## **BRIDGE MILL SUBDIVISION, PHASE II**

The purpose of the application is the creation of a 39-lot subdivision from two metes and bounds parcels.

APPLICATION NUMBER 11 DATE July 7, 2005

## DETAIL SITE PLAN

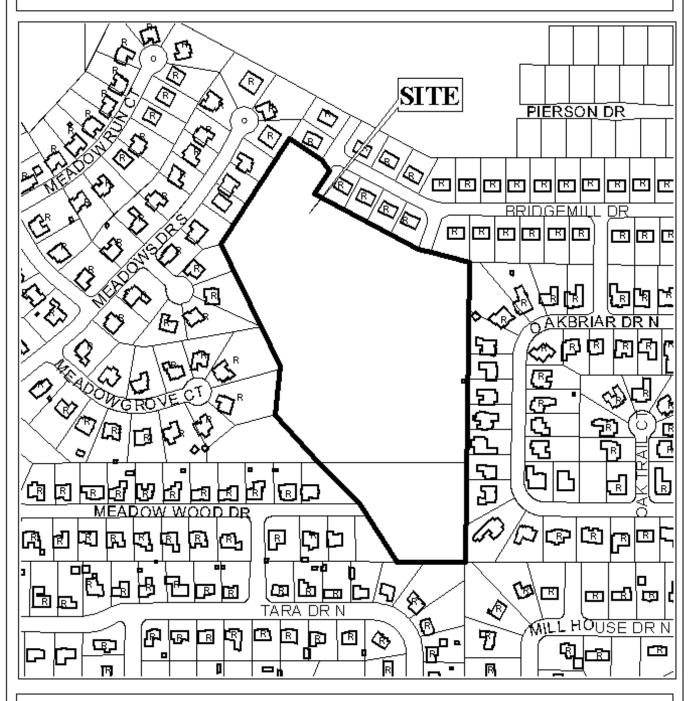
The site extends from Fenwick Loop and Fenwick Loop West, each of which has a 50' right-of-way; and adjoins the East terminus of Meadow Wood Drive, which also has a 50' right-of-way. Meadow Wood Drive is illustrated with a hammerhead turnaround; in the interest of connectivity, and to provide additional points of access, this should be modified to connect to Fenwick Loop. As the site involves the extension of streets, these streets should be constructed and dedicated.

The detention area is labeled as common area with detention; thus a note should be required on the final plat stating that maintenance of the common detention area is the responsibility of the property owners.

The plat meets the minimum requirements of the Subdivision Regulations and is recommended for Tentative Approval, subject to the following conditions: 1) the connection of Meadow Wood Drive and Fenwick Loop; 2) the construction and dedication of the new streets; 3) the placement of a note on the final plat stating that maintenance of the common detention area shall be the responsibility of the property owners; and 4) the placement of a note on the final plat stating that any lots that are developed commercially and adjoin residentially developed property must provide a buffer, in compliance with Section V.A.7 of the Subdivision Regulations.
